DEPARTMENT OF COMMERCE**National Oceanic and Atmospheric Administration**

Takes of Marine Mammals Incidental to Specified Activities; Taking Marine Mammals Incidental to an Exploration Drilling Program Near Camden Bay, Beaufort Sea, Alaska

ACTION: Notice; issuance of an incidental harassment authorization.

Figure 1. Band levels for the Kulluk during drilling.

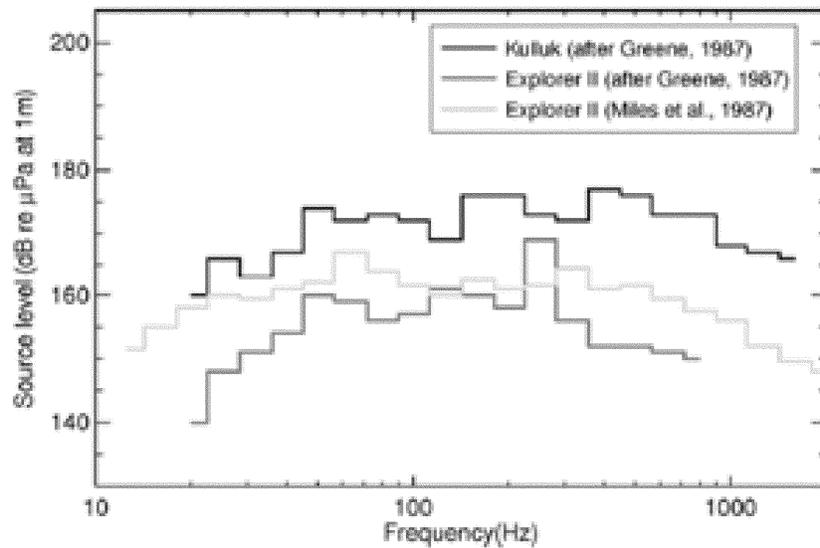
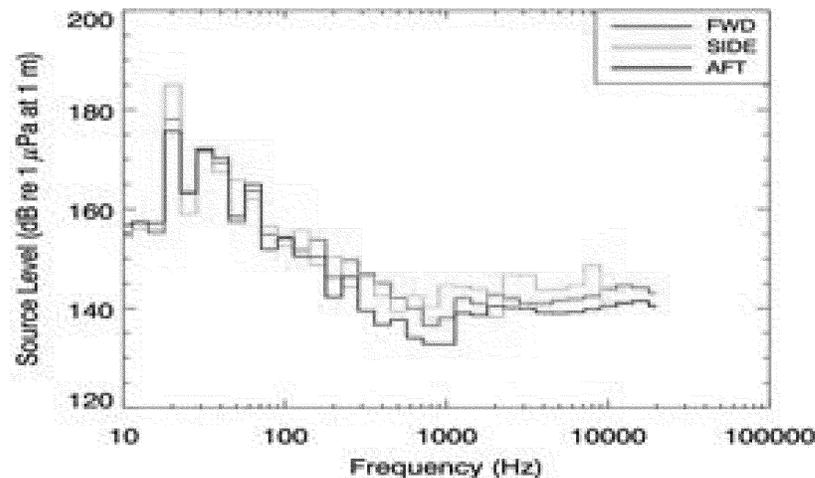
Comment 4: The MMC and AWL question the source levels and harassment zones for the two drillships. If the source levels for the *Kulluk* and *Discoverer* are nearly identical, then why is there a four-fold difference in the size of the corrected harassment zones for the two drilling vessels?

Response: Differences in sound propagation from the two rigs are real and are caused by differences in the design of the two vessels. While the broadband source levels for the

Discoverer and *Kulluk* may be similar, their spectral properties differ considerably. Acoustic modeling considers the source levels in 1/3-octave frequency bands. Figures 1 and 2 show the band levels for both drillships during drilling. Of key importance are the significantly lower levels of the *Discoverer* in the 50 to 500 Hz bands that propagate well in the relatively shallow waters of these drilling operations. While the *Discoverer* apparently has higher band levels below 50 Hz, this energy is more rapidly attenuated than higher frequency sound energy. This characteristic of sound propagation in shallow waters leads to predominantly mid-frequency sounds (50–500 Hz) dominating the acoustic field at distance from the drillships. A further consideration is that the *Kulluk* source levels are known to include contributions from support vessels, and much of the mid-high frequency band energy in its source levels may not originate entirely from the drillship itself, as acknowledged by Greene (1987). The *Discoverer* source level measurements by Austin and Warner (2010) were made at closer distances and do not include significant contributions from other vessels. The *Kulluk*'s modeled sound footprint may be an overestimate as a result, but we cannot quantify by how much since the relative contribution of vessel noise to its source level measurements is unknown. The source level for the *Discoverer* was measured, though not in the Beaufort Sea, and those measurements were used to model propagation in the Beaufort Sea environment. Regardless of which drill rig is used by Shell in the Beaufort Sea in 2012, the IHA requires Shell to conduct sound source verification (SSV) and characterization tests on all equipment used.

Figure 3. Sound speed profile used in drill rig modeling.

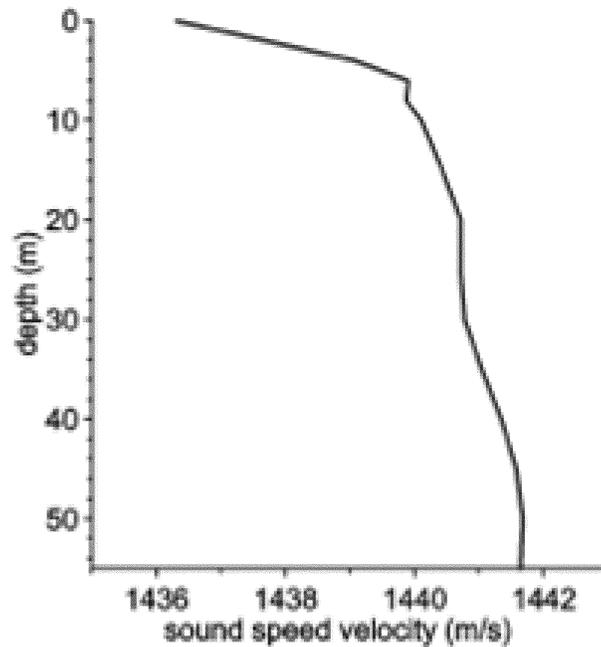
Comment 26: Dr. Bain states that the correction factor of 1.5 applied to the distance to the 120 dB contour is inadequate to conservatively account for the variability.

Response: The concern raised here is that the sound speed profile used for acoustic modeling of drill rig noise may not account for changes to the salinity and temperature profile that could influence and create variability in sound propagation, and the resulting variability might lead to conditions in which model estimates would not be conservative. While significant structure can form in the sound speed profile, the profile used for this modeling study was taken from the GDEM database for the corresponding locations and timing (month of September was used). The specific profile chosen (see Figure 3) has increasing sound speed with depth over the full water column. This profile leads to upward acoustic refraction that causes propagating sounds to bend up, thereby reducing interactions with the seabed. This situation generally reduces acoustic transmission loss as a result of acoustic energy being lost due to reflection and scattering from the bottom. It is believed to produce longer propagation distances than the stratified profile that sometimes forms with warmer high speed water overlying cooler water. That profile would be downward-refracting and would lead to more bottom interaction and sound energy loss. Therefore, a correction factor of 1.5 is appropriate in this circumstance.
